## EXHIBIT 2 - STAFF REPORT

DATE: June 24, 2021  
TO: Historic Landmark Committee Members  
FROM: Chuck Darnell, Senior Planner  
SUBJECT: DDR 1-21 (Downtown Design Review for New Construction) – 631 NE 1<sup>st</sup> Street

**Figure 2. South and West Facing Elevations**

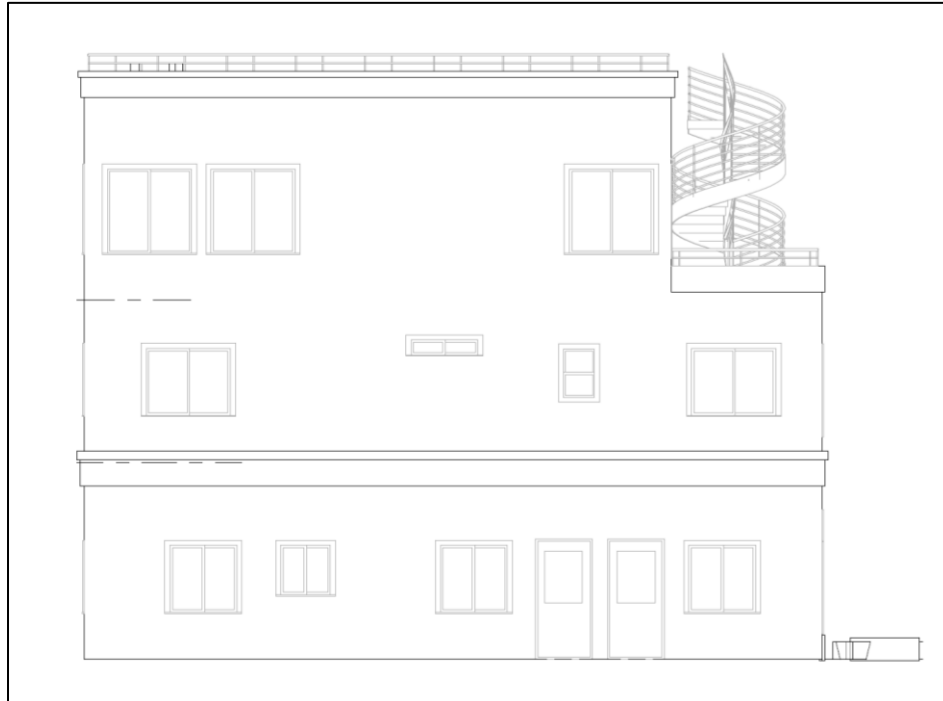
Overall, staff concurs with most of the applicant's narrative and findings. Staff believes that much of the project design does meet the applicable Downtown Design Standards. The building is proposed to include a small setback to allow for a plaza space on the front of the building, which is allowed as an exception within the code and will be discussed in more detail below. The building includes a recessed primary entry on the front façade, all of the storefront façade features (glazing, belt course, decorative cap at roofline, etc.) required for the front elevation, and is proposed to be finished with smooth stucco which is an allowable exterior building material. Some of the architectural features, including the belt course (horizontal trim band between the first and second stories) and the decorative cornice/cap feature are proposed to extend along all four building elevations which provides for more visual interest in those side and rear façades.

One of the few areas where the proposal deviates from the typical Downtown Design Standards is on the front building setback, which is typically required to be zero feet from the property line. However, MMC Section 17.59.050(A)(2) specifically allows the following: "Exceptions to the setback requirements may be granted to allow plazas, courtyards, dining space, or rear access for public pedestrian walkways." The applicant has identified a plaza space on their site plan in the front of the building, between the building wall and the adjacent sidewalk along 1<sup>st</sup> Street. The applicant also provided reasoning for this plaza to help with some aspects of site design and functionality, given that the property in question is a somewhat small lot (about 4,000 square feet). This reasoning was provided partly in the form of findings for the plaza and slight setback as a waiver from the typical zero setback requirement. However, the setback is the only Downtown Design Standard that is listed in the code as being able to be provided as an exception (see Section 17.59.050(A)(2) language above), so a waiver is not specifically required. Staff believes that the setback exception could be granted in this case to allow for this plaza space to exist, given the applicant's reasoning and the unique characteristics of the lot. Some of those unique characteristics

A couple of other Downtown Design Standards that are unique in this proposal are the standard in MMC Section 17.59.050(B)(1) related to buildings having “massing and configuration similar to adjacent or nearby historic buildings on the same block”, and also the standard in MMC Section 17.59.050(B)(4) related to the orientation of rooflines of new construction being “similar to those of adjacent buildings”. MMC Section 17.59.050(B)(4) goes on to state that “Gable roof shapes, or other residential roof forms, are discouraged unless visually screened from the right-of-way by a false front or parapet.”. The applicant has proposed a building design that is intended to meet all of the applicable Downtown Design Standards. In doing so, the applicant notes that the visual appearance is not similar to adjacent nearby historic buildings on the same block. Staff would concur with this, and would note that the Downtown Design Standards are not written in such a way as to encourage a typical residential building form, but more of a commercial storefront type of building form. That being said, staff believes that the proposed “massing and configuration” of the proposed building can be found to be similar to adjacent and nearby historic buildings on the same block. These adjacent historic buildings are larger scale single family dwellings, most being 2.5 stories in height and of a larger building footprint. The proposed new building has a similar building footprint and configuration of placement on the lot, and the massing and building height overall is not substantially different from these larger adjacent historic residential homes, even though the new building will be different in visual appearance and style. In regards to the roofline orientation, the applicant has proposed a flat roofline and referenced the fact that the adjacent post office building has a flat roofline. In addition, the standard for roofline orientation specifically discourages gable or other residential roof forms. For these reasons, staff believes this roofline orientation standard is also being achieved.

**Figure 3. Building Rendering****Discussion:**

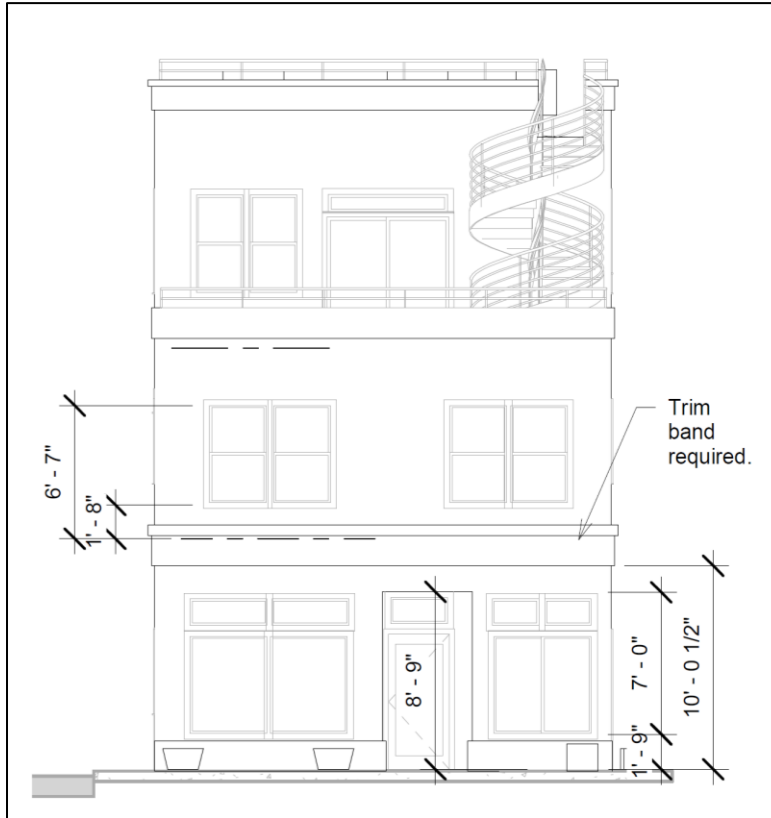
One other component of the proposed building design that is not specifically referenced in the decision document is the balcony and rooftop deck, and exterior staircase providing access to the rooftop deck. These features are included on the building design, with the balcony on the third story in the area where the building wall steps back. On the balcony is an exterior staircase providing access to the proposed rooftop deck. Staff does not believe that there are any specific Downtown Design Standards that prohibit these types of features from being included on the building. Staff actually believes that they are beneficial features to have included in the mixed-use building design as they provide for some more usable open spaces for the future residents of the two dwelling units on the lot that is somewhat small and lacks other forms of usable open space after lot area is utilized for vehicle parking spaces and drive aisles. The primary components of these features that will be visible will be the railings along the balcony and rooftop deck and the staircase, but staff believes they are well incorporated into the building design by using the same coloring as the windows and building trim.

Finally, the applicant did provide renderings that identify the colors of the building and described in their narrative that the colors applied to the building would be subtle, neutral, or earth tone. The colors shown in the rendering consist of shades of grey, which are generally all subtle, neutral, and earth tones. To ensure that the final colors applied to the building are subtle, neutral, and earth tone in color, a condition of approval is included to require that the applicant provide samples or examples of the exterior building colors to the Planning Department for review and approval by the Planning Director prior to application on the building.

4. That the applicant shall provide samples or examples of the exterior building colors to the Planning Department for review and approval by the Planning Director prior to application on the building.
